STAFF REPORT
COMMUNITY DEVELOPMENT DEPARTMENT

HEARING DATE: 04/14/2026
TO: Mayor & City Council
FROM: Nick Napoli, Associate Planner
nnapoli@meridiancity.org
SUBJECT: Apex Zenith
FP-2026-0006
LOCATION: Located at the southeast corner of Meridian Road and Lake Hazel Road in a portion of Lot 4 of Section 6, T.2N., R.1E.

Final plat consisting of seven (7) building lots on 11.065 acres of land in the C-G zoning district for the Apex Zenith.

B. Final Plat (dated: 02/20/26)

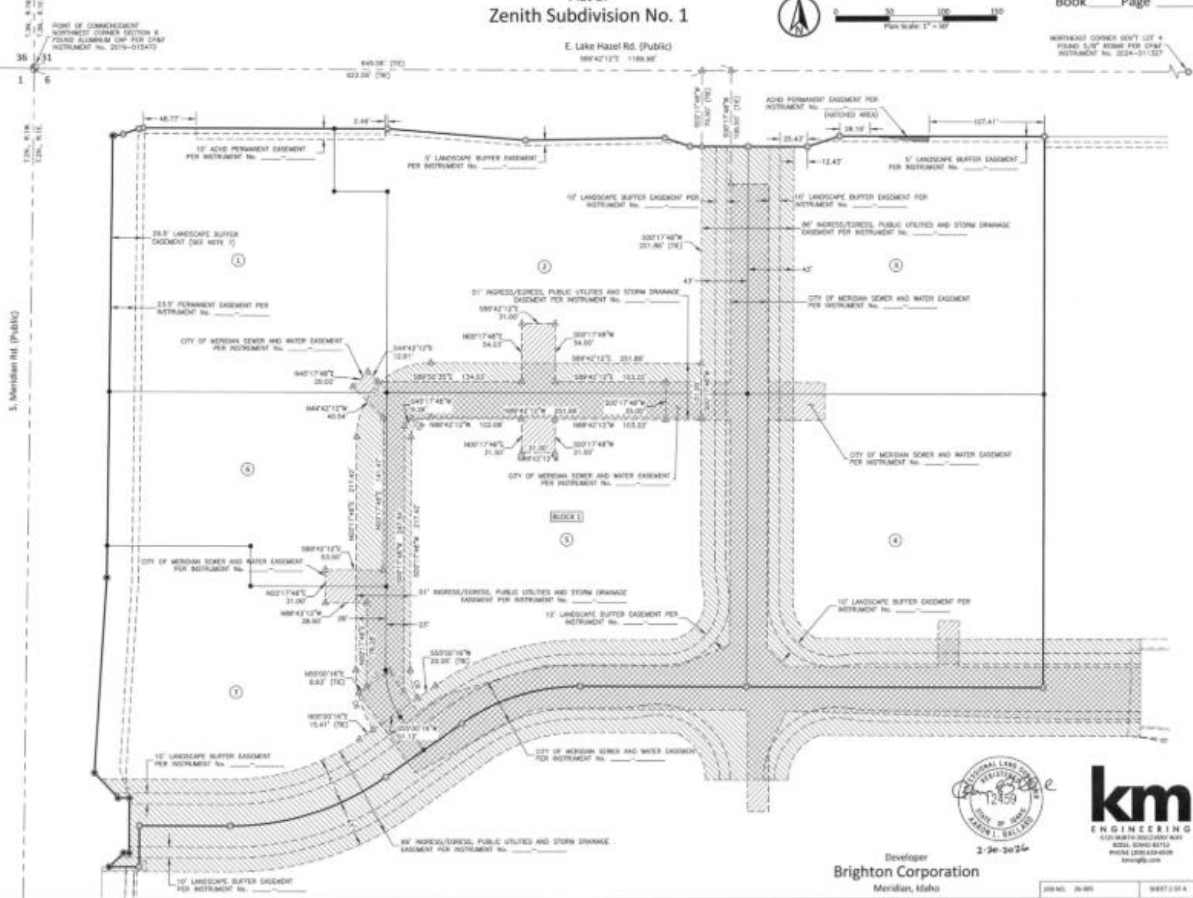
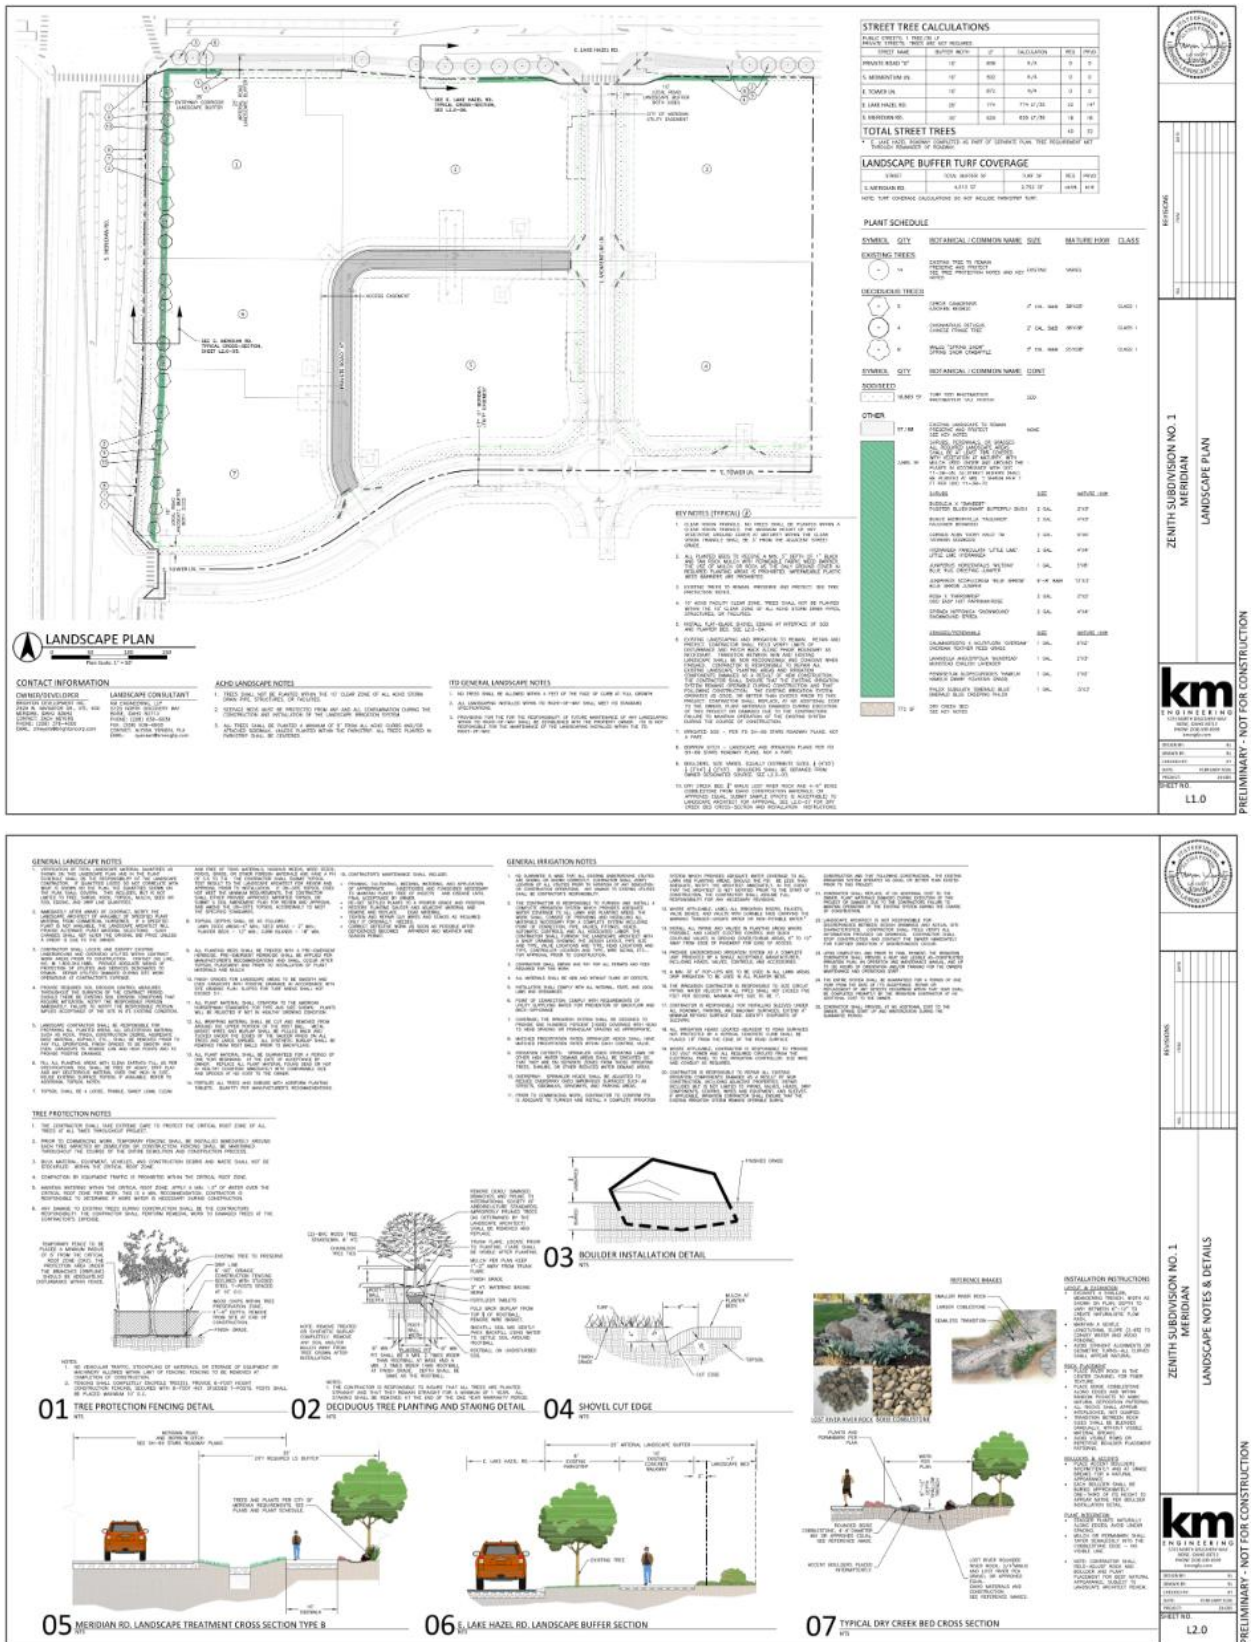
- a. Provide the license agreement from ACHD and ITD for landscaping within the transportation authority's right of way.
 - b. Add a plat note or reference the CCR instrument number for cross-access and maintenance of the private streets.

- c. Revise the plat and landscape plans to include the dimensions of the pathways.
A copy of the revised plat shall be submitted with the final plat for City Engineer signature.
